Washington State Department
of Transportation

REQUEST FOR PROPOSALS:
For the Selection of Roadway Design Software

Addendum One

October 4, 1996

Figure 1
Match Existing Slope
Requirement No. 3.4.7.7

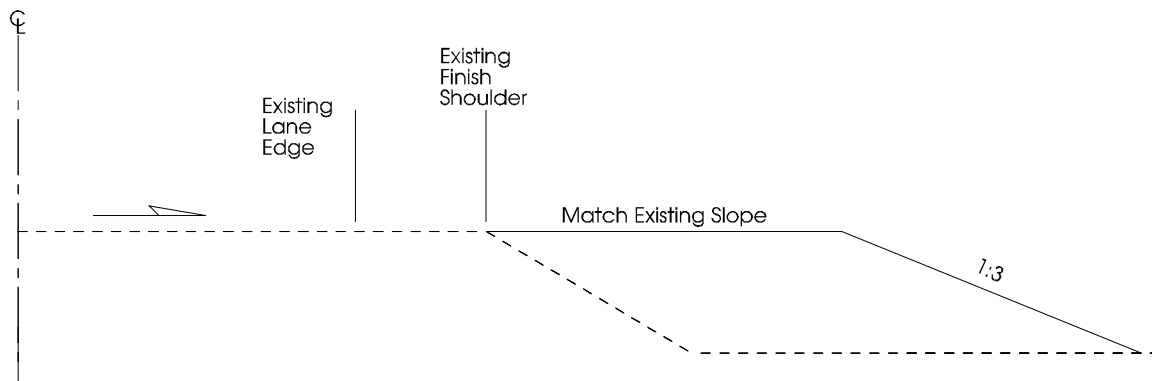
Question:	Brian Fletcher, Intergraph	He asked for clarification of requirement 3.4.7.7 Match Existing Slope , page 21 of the RFP. He referred to page 37, Figure 1, Figures 3.11 .

Question:	Sum Lin, Geopak	Are you looking for a profile, or cross-section?
Answer:	Terry Ness	Terry referred to the existing Figure 1, and replied that a cross-section could be established for Point C.

Question: Dave deRosier, C.W. Beilfuss
He requested that requirement **3.8.2.15** Broken Back, not be a mandatory requirement, but be changed to a custom mandatory. He also requested that requirement **3.4.7.7** Match existing Slope, be changed to a custom mandatory.

Answer:	Jim Krehmeyer	We are evaluating Windows NT 4.0 but will not migrate to it for some time. We will continue to use Windows NT 3.5.1.
Question:	Terry Ness to Dave deRosier	Regarding 3.4.7.7 Match Existing Slopes. Dave had mentioned that other DOTs do this differently than how we are requesting. How do they do it for roadway widening?

Answer:	Terry Ness	We are looking to match the existing slope in the event that we are widening the roadway. We're looking for the capability for the software to determine what the existing pavement is, and match the existing slope.

In consulting with the team, we determined that we will keep 3.4.7.7 a mandatory requirement.

3.4.7.7 Match Existing Slope (MR) Must have the ability to construct and store a proposed roadway segment (lane and/or shoulder) whose slope will match the existing roadway slope.
